**PRELIMINARY DRAINAGE REPORT  
FOR  
STERLING RANCH PHASE 2 PRELIMINARY PLAN**

**Engineering Review**

**October 1, 2020  
Project No. 25188.02  
SP-20-003**

# VICINITY MAP

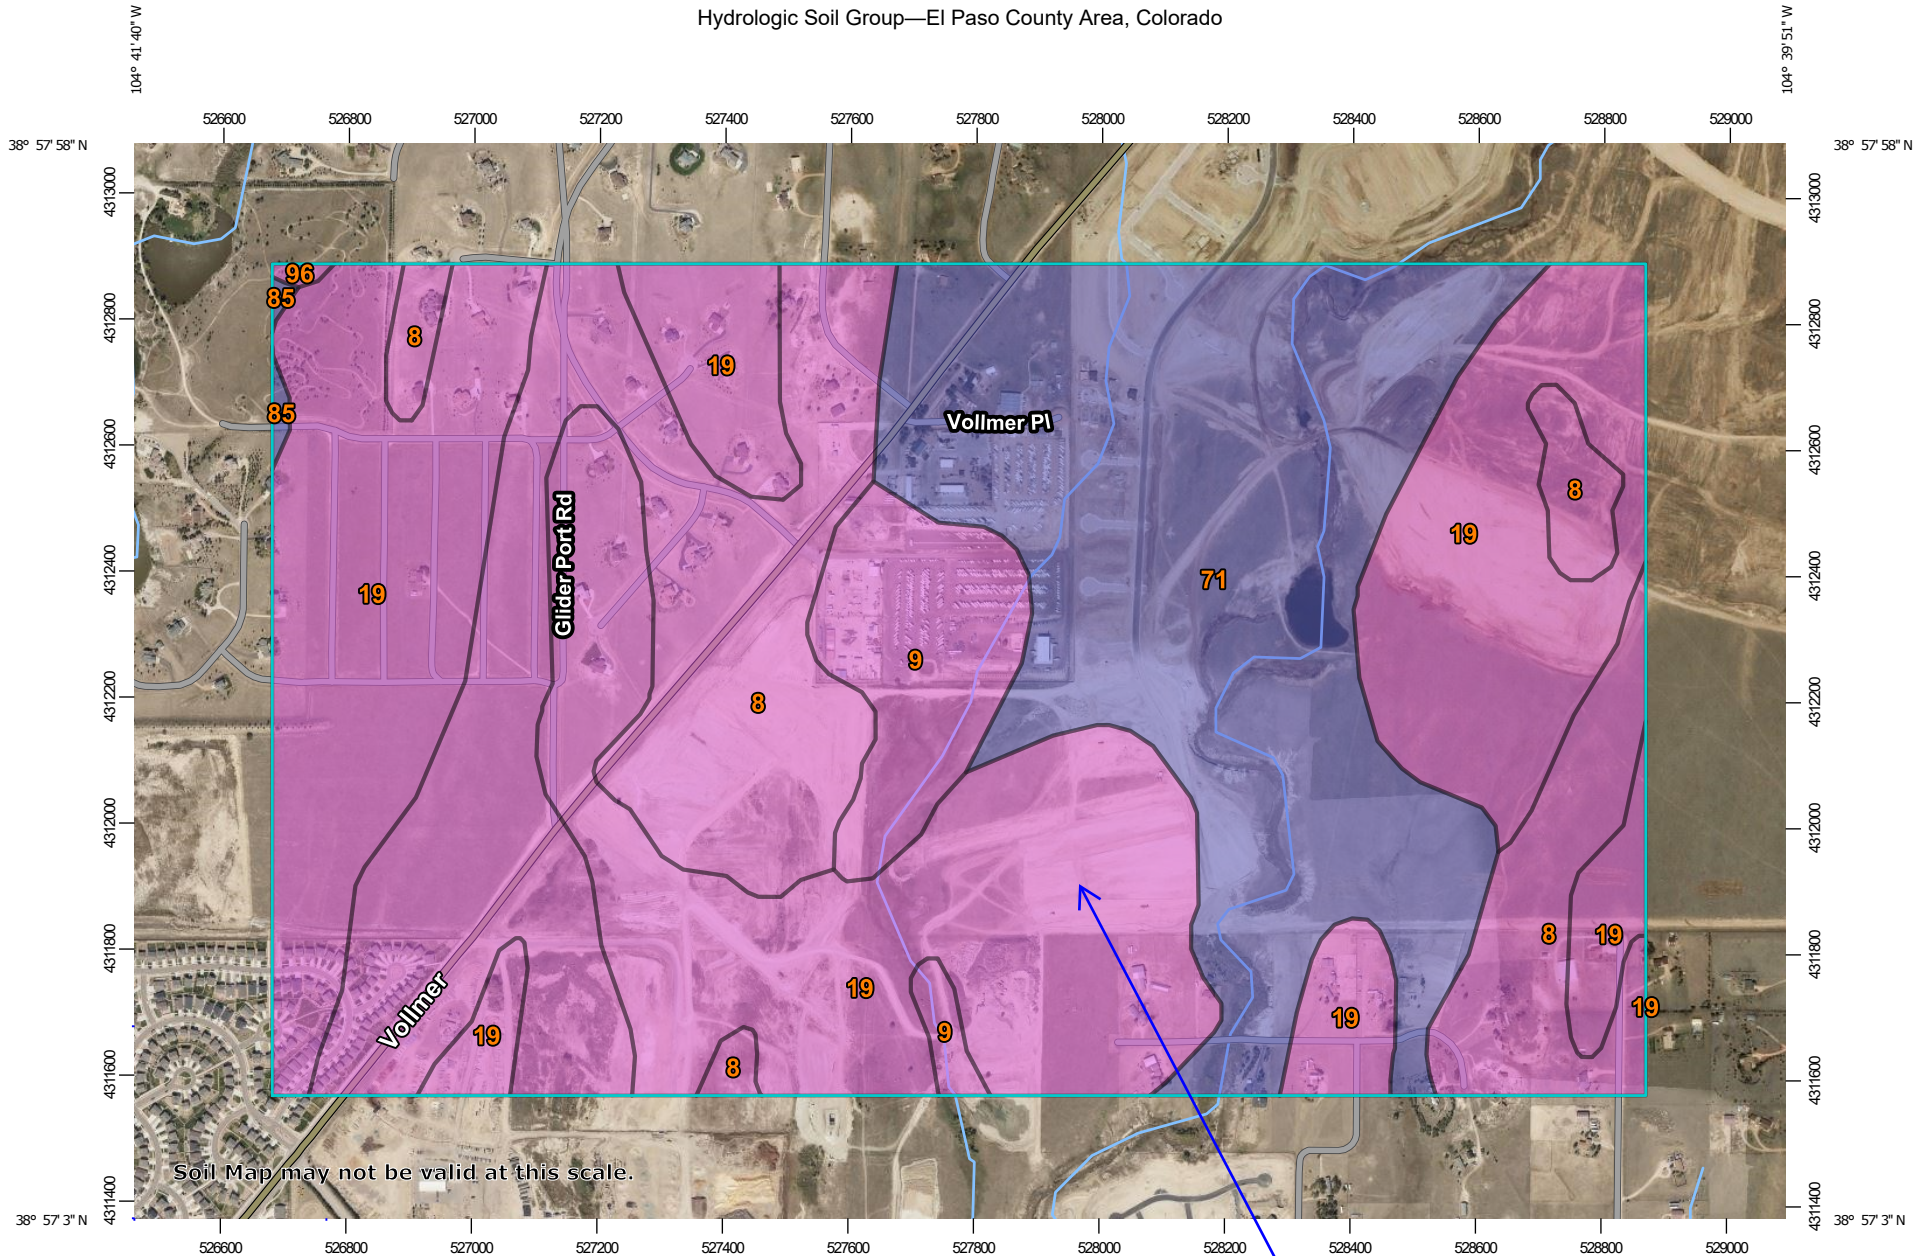
show the site

STERLING RANCH PHASE 2  
 PROPOSED DRAINAGE MAP  
 JOB NO. 25188.00  
 09/25/20  
 SHEET 1 OF 2

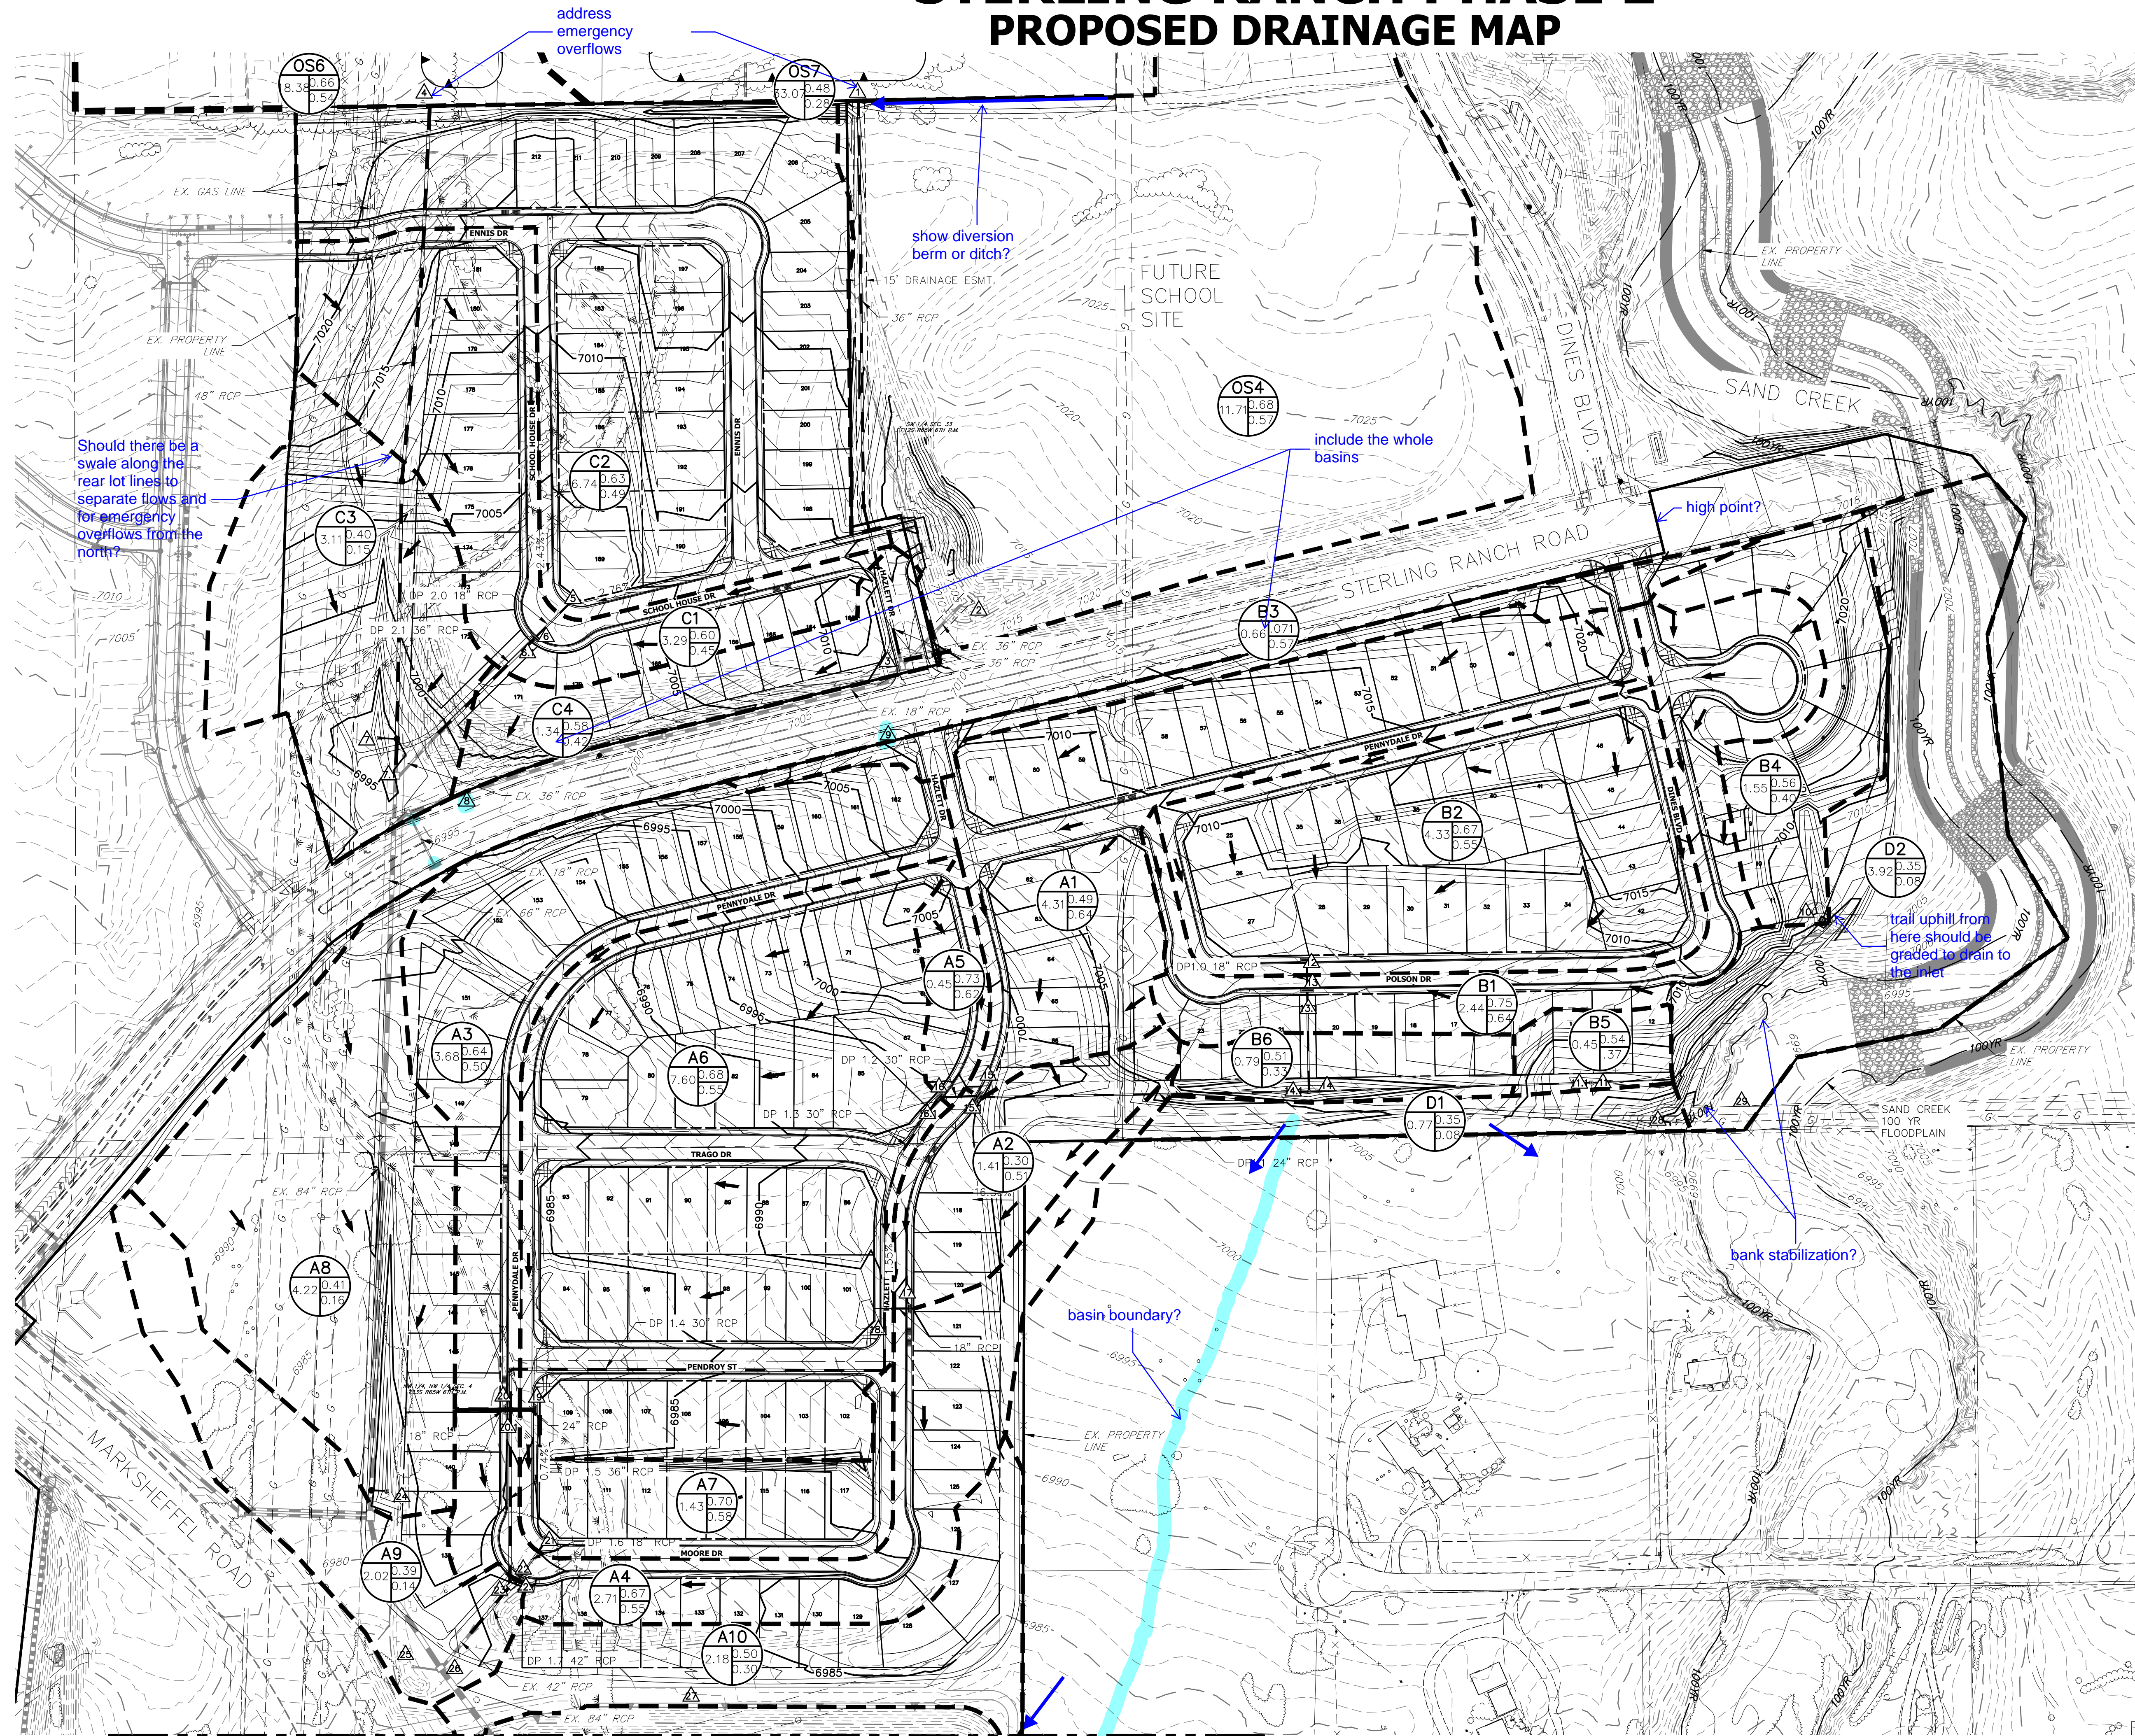
Also provide DP summary
